March 2, 2026
ADDENDUM NUMBER ONE
Project No. ENG2603767100
For Department of Natural Resources

**DEAM LAKE CULVERT REPLACEMENT
DEAM LAKE STATE RECREATION AREA**

Project: Deam Lake SRA Culvert Rehabilitation & Replacement File: 24-13468

SHEET TITLE:
PROJECT A - CAUSEWAY PLAN &
PROFILE

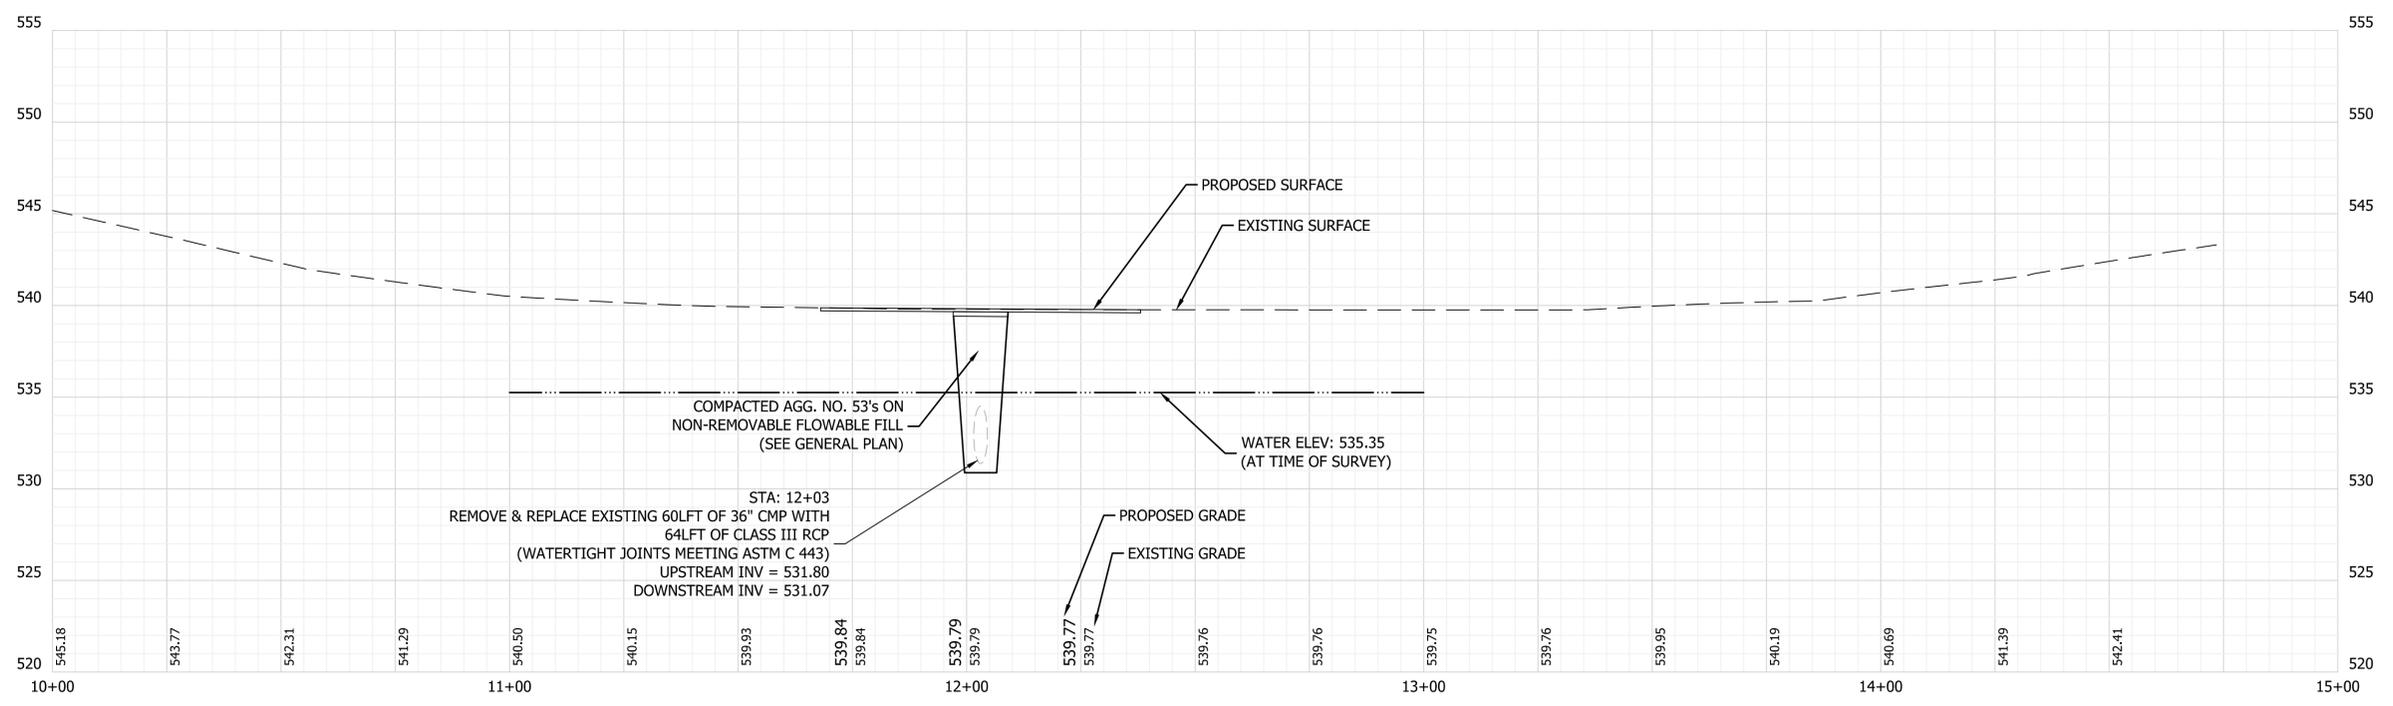
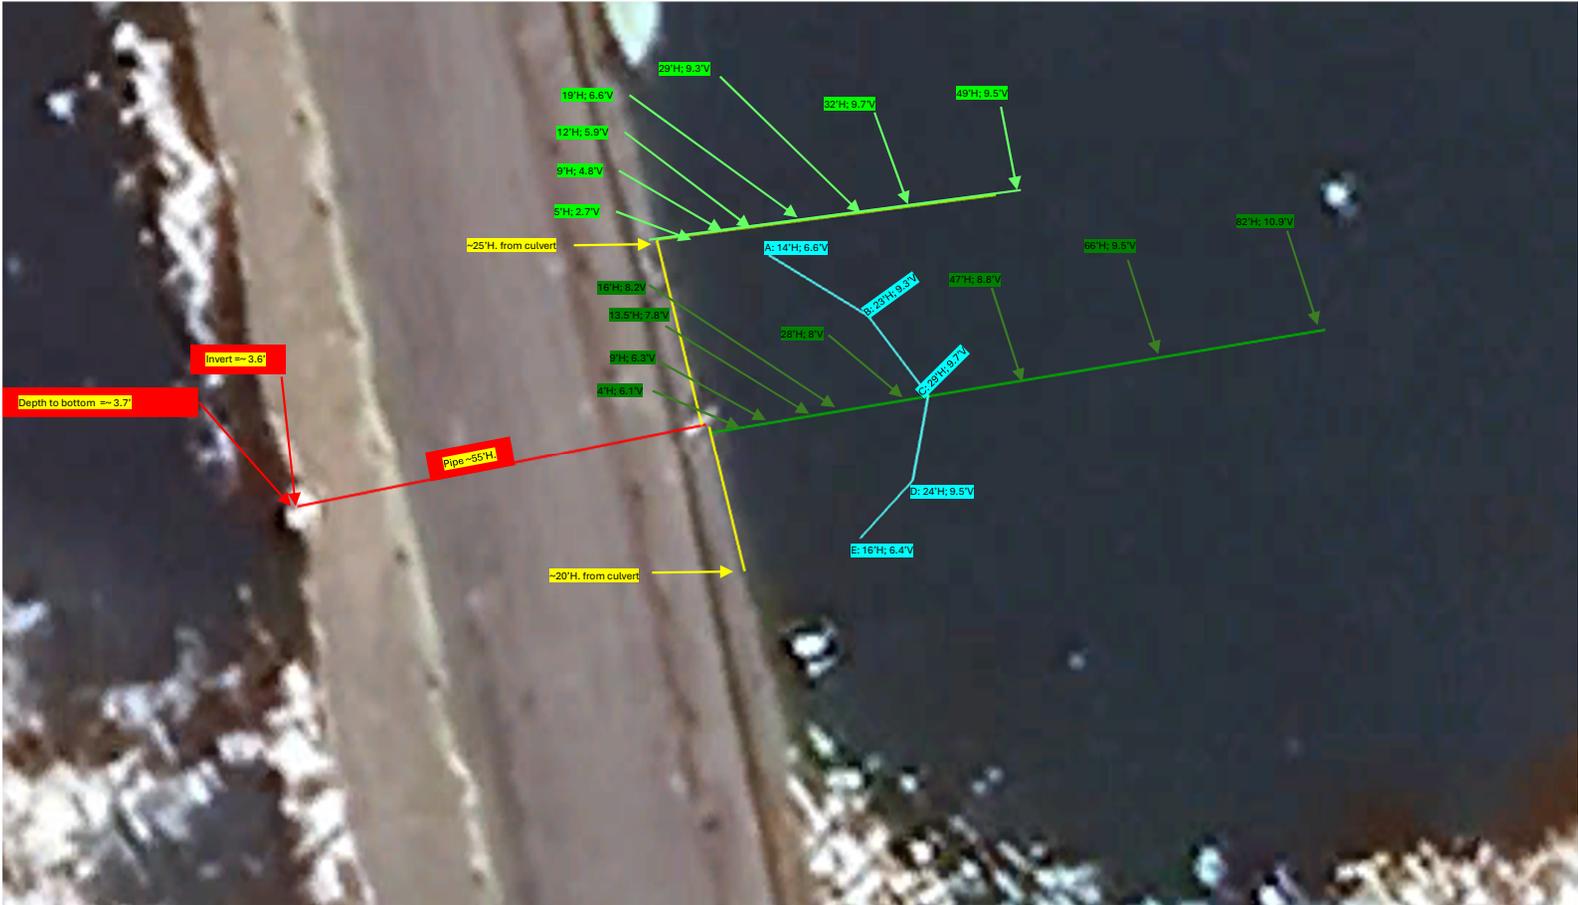
ITEM NO. 1 - Sheet 3: Existing 6" PVC (Dry Hydrant) has been shown on plan sheet:

Existing 6" PVC (dry hydrant) shall be removed for construction and installation of the new 36" RCP. Dry hydrant shall be re-installed upon completion.
